# $C_{eq}$ report in TDECQ penalty computation

Laurent Alloin, Eric Maniloff, Amitkumar Mahadevan  
Ciena

# Example of impact of a reflection – FFE only

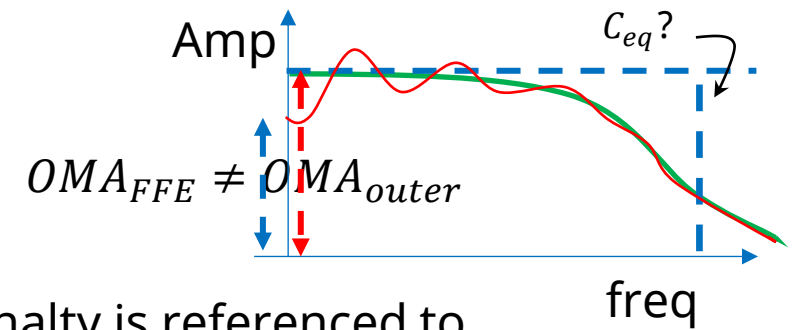
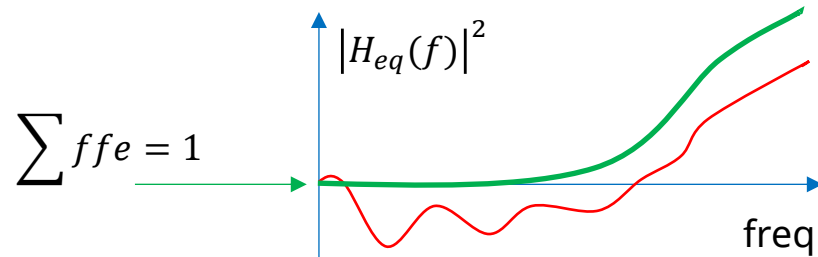
In case of a destructive reflection  $OMA_{FFE} < OMA_{outer}$ , as  $OMA_{outer}$  measured per SC 180.9.5 is equivalent to the OMA of a transmitter without the impact of the reflection.

However,  $C_{eq}$  is assessed with respect to  $OMA_{FFE}$ , while the TDECQ penalty is referenced to  $OMA_{outer}$  to remain independent of the impact of the reflection.

The  $C_{eq}$  value appears different for modules of same bandwidth but with different reflections

When considering TDECQ –  $C_{eq}$ , both quantities need to be referenced to the same  $OMA_{outer}$  level. Since  $OMA_{FFE}$  varies with the type of reflection (constructive vs destructive), while  $OMA_{outer}$  is independent of the reflection, TDECQ –  $C_{eq}$  may not be correct for modules that have a same bandwidth and a same  $OMA_{outer}$ .

# Consequence for TDECQ-CEQ computation – FFE only

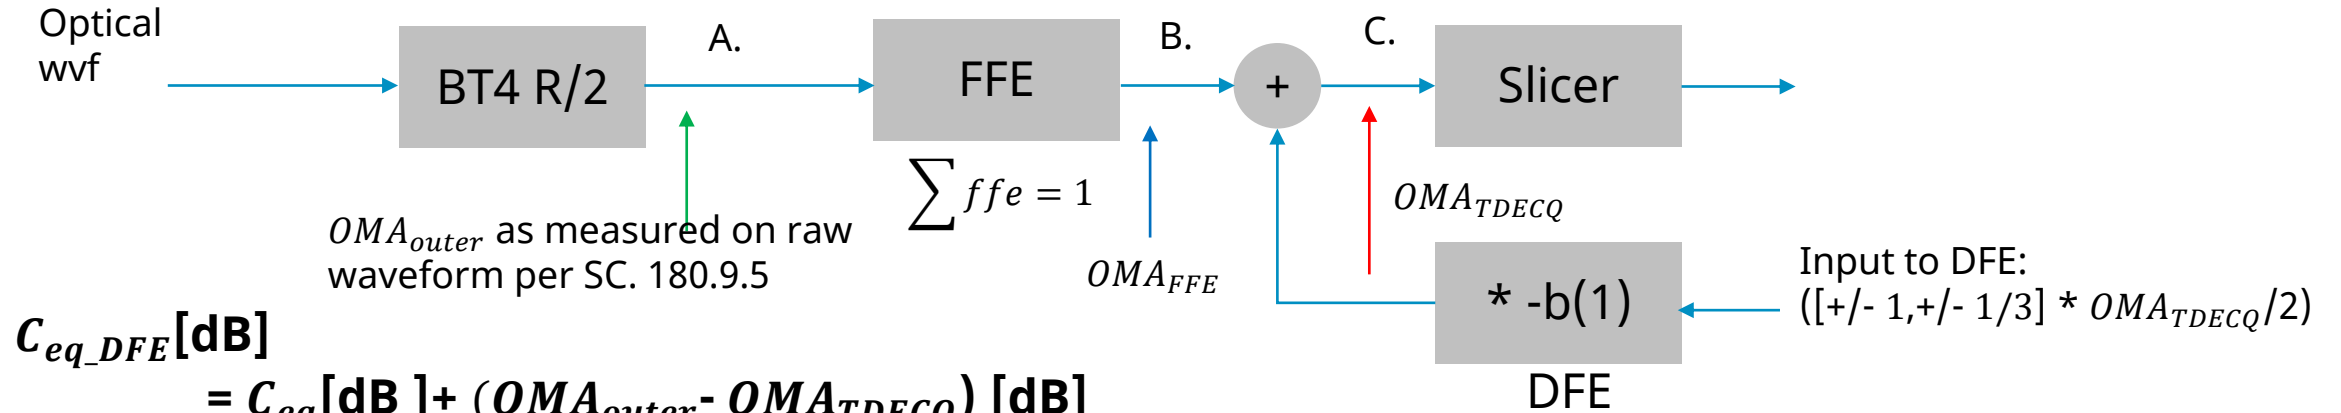
← Inconsistent BW metric

← Consistent BW metric

← Inconsistent un-equalizable terms

Mod #3 will be flagged as undershooting  
 Mod #1 will be flagged for overshooting  
 But all 3 modules offer very similar bandwidth !

Whereas  $C_{eq\_FFE}[\text{dB}] = C_{eq}[\text{dB}] + (OMA_{outer} - OMA_{TDECQ})[\text{dB}]$  shows that all 3 modules are similar. Hence, TDECQ -  $C_{eq\_FFE}$  estimates are now consistent, while TDECQ -  $C_{eq}$  estimates are not
